Potential Acquisition of Monterey Water System and District Boundary Adjustment

Final Environmental Impact Report

Monterey Peninsula Water Management District

Figure 2-2 District and Project Boundaries

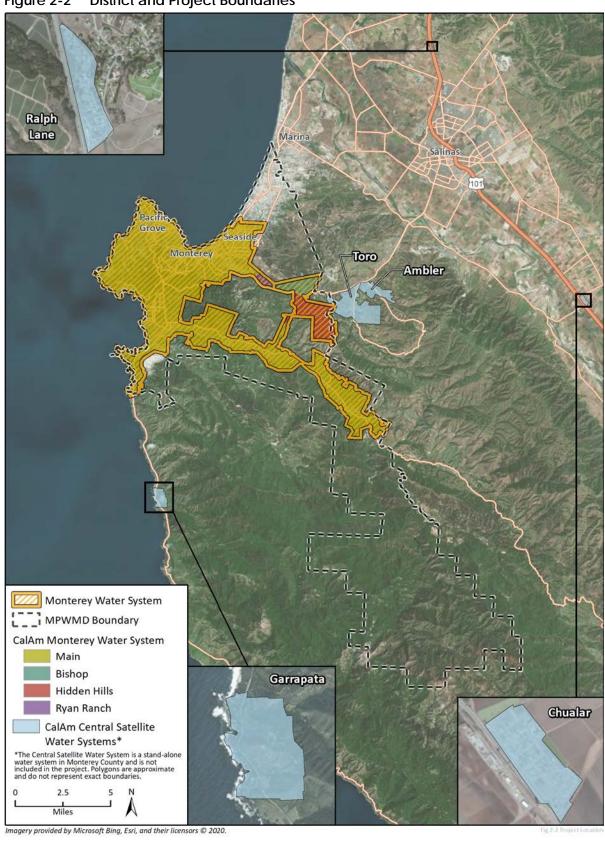
Although we do not live in your district, this document could potentially affect us. On page 2-3, Figure 2-2, which is entitled "District and Project Boundary" incorrectly shows the boundary for the Garrapata satellite system. A note in the legend box states that Polygons are approximate and do not represent exact boundaries, is inadequate since the very purpose of this document is to consider changing boundaries. Our property appears to be shown inside the polygon for the Garrapata satellite system. We are upstream of that system and have always been outside the water company's service area, as well as outside your district's boundary. We further understand that satellite systems such as Garrapata are not included in the acquisition but since they are operated by CalAm, it is hard to see that they would not in some way be impacted, since they use common personnel, equipment and facilities.

The commenter notes the project site boundary in Figure 2-2 is inaccurate and includes their facility and asks that the figure be revised to reflect the project boundaries more accurately.

Figure 2-2 shows the most up-to-date service area boundaries for CalAm as identified in the 2015 UWMP (see Figure 3-1 in the 2015 UWMP) and shows the abandoned trout farm within the Garrapata System. As such, the figure is correct and has not been updated in response to this comment.
